Nine Mile Point Nuclear Station, Unit 2  
Renewed Facility Operating License No. NPF-69  
NRC Docket No. 50-410

Subject: License Amendment Request - Safety Limit Minimum Critical Power Ratio  
Change

GNF-002N8791-R1-NP

## **GNF Additional Information Regarding the Requested Changes to the Technical Specification SLMCPR**

**Figure 1. Current Cycle Core Loading Diagram**

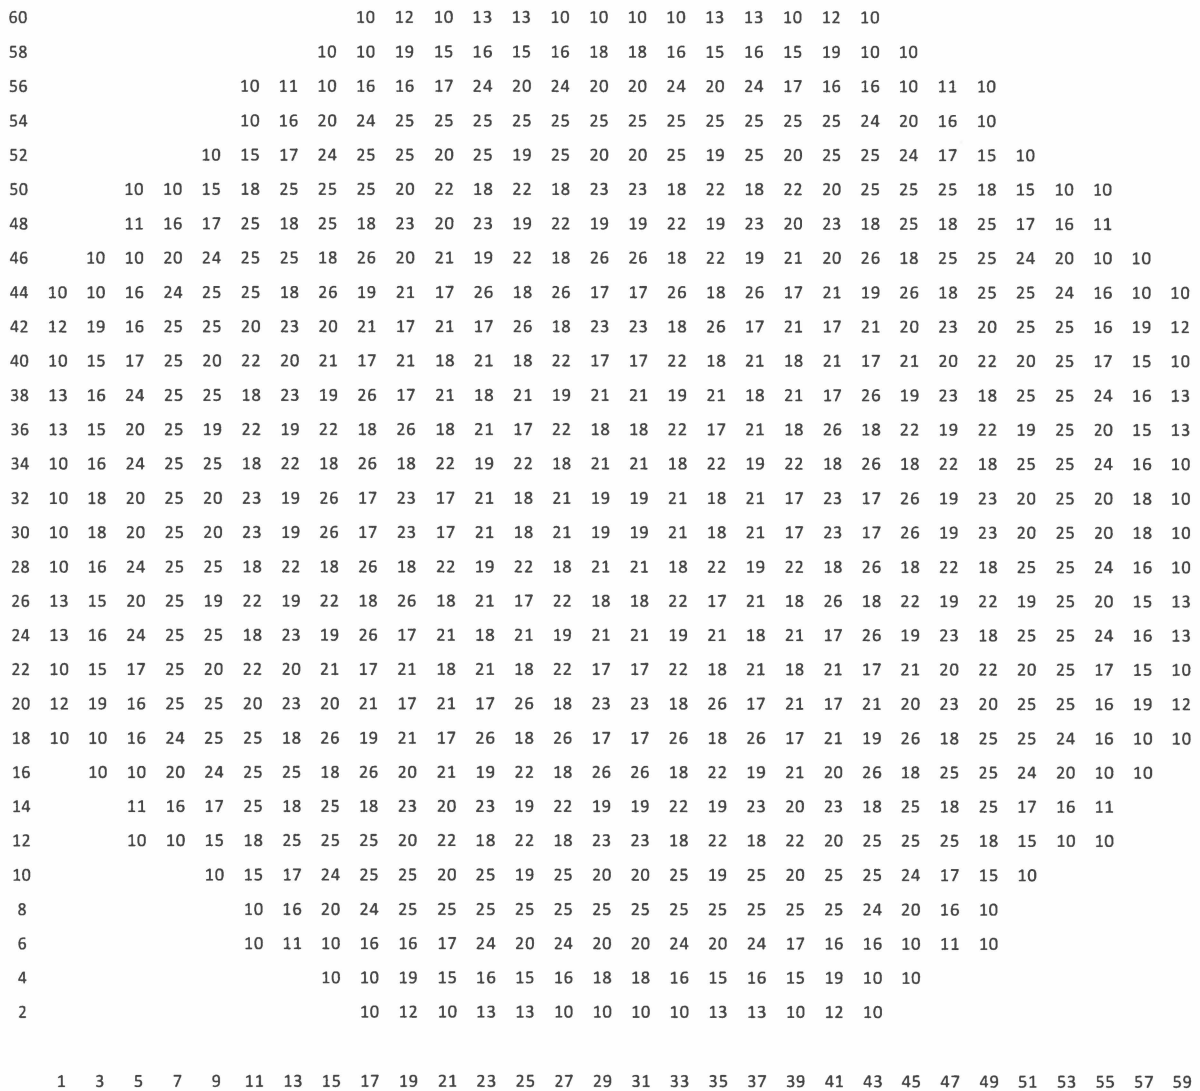
Figures 1 and 2 provide the core-loading diagram for the current and previous cycle respectively, which are the Reference Loading Pattern as defined by NEDE-24011-P-A. Table 1 provides a description of the core.
